**Subject:** MHI's Second Responses to US-APWR DCD RAI No.234

Response to Request for Additional Information No. 234-2040  
Revision 1

**US-APWR Design Certification**

**RAI NO.:** NO. 234-2040 REVISION 1  
**SRP SECTION:** 06.05.02 – CONTAINMENT SPRAY AS A FISSION PRODUCT CLEANUP SYSTEM  
**APPLICATION SECTION:** 6.5.2  
**DATE OF RAI ISSUE:** 2/26/2009

Figure 06.05.02-1 Variation of recirculation water pH with time

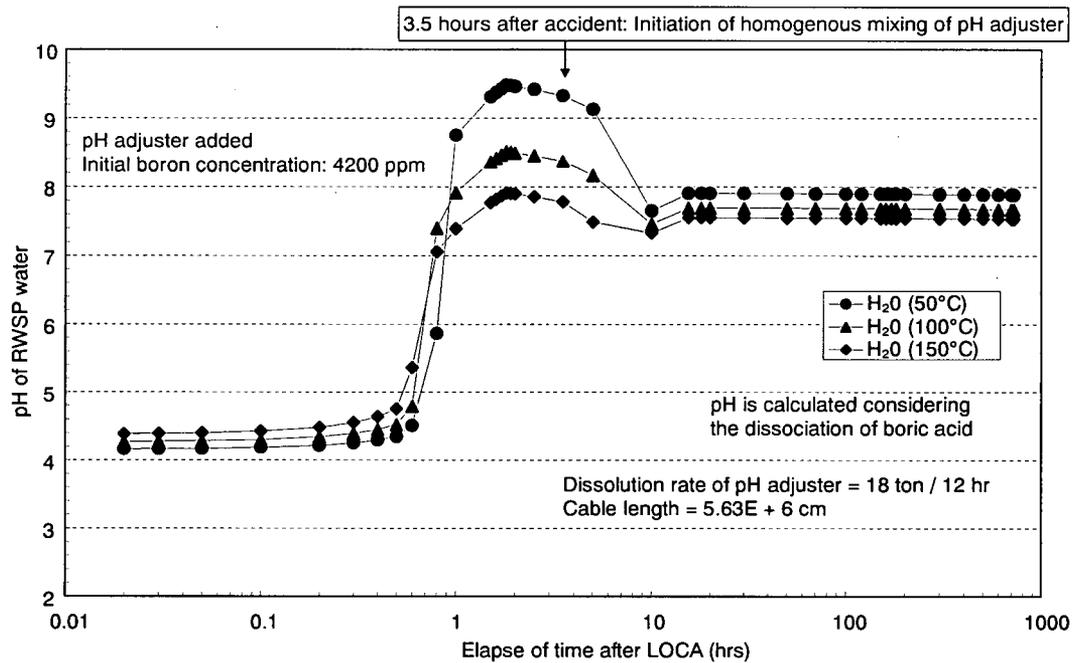
- a. Under DBA conditions, how long does it take for the RWSP water to reach a pH of 7 due to dissolution of NaTB?
- b. What is the dissolution rate of NaTB?

d. The pH variation with time calculated considering factors described below that contribute to the recirculation water pH after an accident is described in aforementioned Figure 06.05.02-1.

The contribution due to generation of carbonic acid (H<sub>2</sub>CO<sub>3</sub>) by dissociation of dissolved carbon dioxide was omitted since carbonic acid is a weak acid and the contribution is minor. Figure 06.05.02-1 shows the calculation result of the recirculation water pH variation from the initiation of dissolution of pH adjuster (NaTB) at 3.5 hours after an accident to complete dissolution at 15.5 hours after an accident considering the dissolution delay of pH adjuster (NaTB) to recirculation water.

According to Figure 06.05.02-1, the recirculation water pH increases with the transition of time after an accident and reaches pH>7 at 0.8 hour after an accident. It is considered that this result was obtained since the contribution by release of alkali (CsOH) was higher than the contribution by (initial) contained boric acid immediately after LOCA and the contribution by generation of acid (HI, HCl, HNO<sub>3</sub>) after an accident. The increase margin of pH decreases after that point since it is considered that the contribution by generation of acid (HNO<sub>3</sub>, HCl) increases due to radiolysis. The pH gradually decreases to the point around 7 immediately after the addition of NaTB since the dissolution amount is small but pH>7 is maintained after NaTB is completely dissolved.

The calculation result of Figure 06.05.02-1 shows that the recirculation water pH at the time when the pH adjuster was added (3.5 hours after an accident) is higher than 7, which means that dissociation of boric acid cannot be ignored. Hence, the recirculation water pH of Figure 06.05.02-1 is calculated using the expression (06.05.02-2) considering the dissociation of boric acid.
